Modification Recommended Service Note

N8950A - Autoranging System DC Power Supply, 1000V, 30A, 10000W, 400 VAC

Serial Numbers: DE14290000 - DE15369999 without manufacturing ID Version "B"

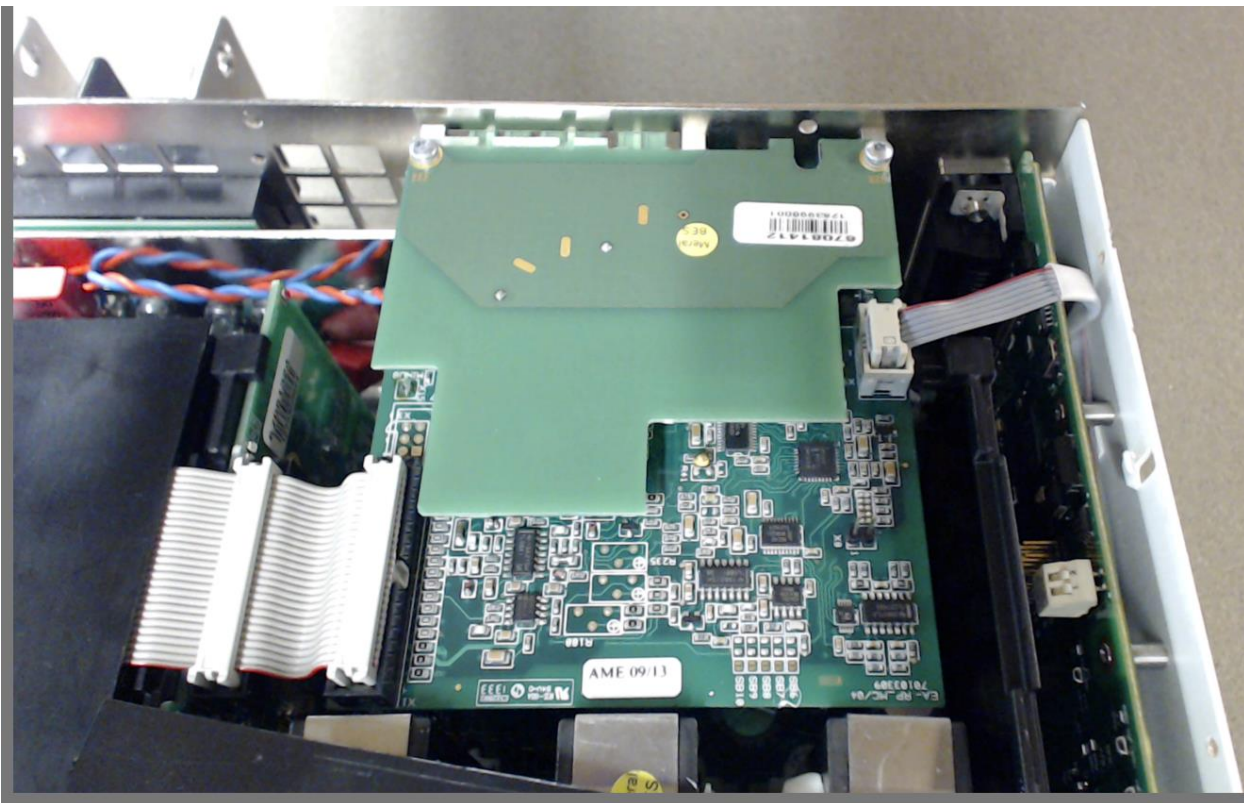
Resistors R93 and R94 must be removed, no replacement parts are required for modification.

Removal of two (2) surface mount resistors, R93 and R94, will correct this problem:

- 1) Remove acMains cable from power source.
- 2) Wait 5 minutes
- 3) Remove top cover from instrument.
- 4) In the 5kW units (viewed from the front of the unit), a small SMT assembly located at the right-rear of instrument will be readily visible (see below):

In the 10kW & 15kW units; although found in the same location, a black plastic cover will have to be removed to gain visibility and access to the SMT assembly. Plastic cover snaps-on and can be removed with a small screwdriver.

Suffix “B” added

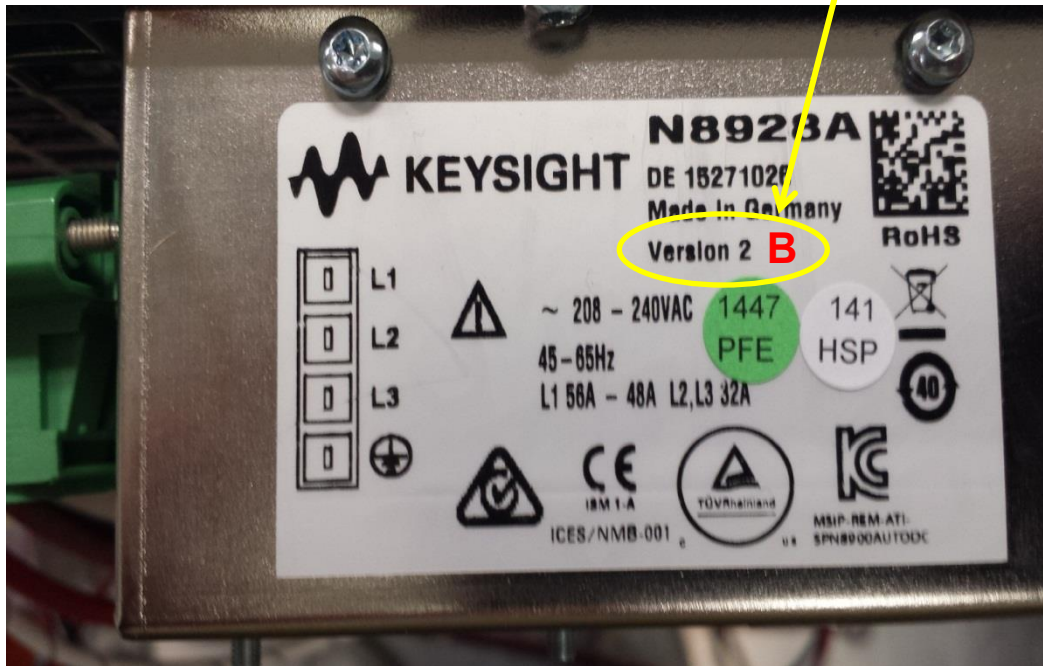
7) On the acMains label, on the rear of the instrument; use an indelible marker, to add the suffix letter “B” after the Version ID. This will assist in the tracking of modified instruments.
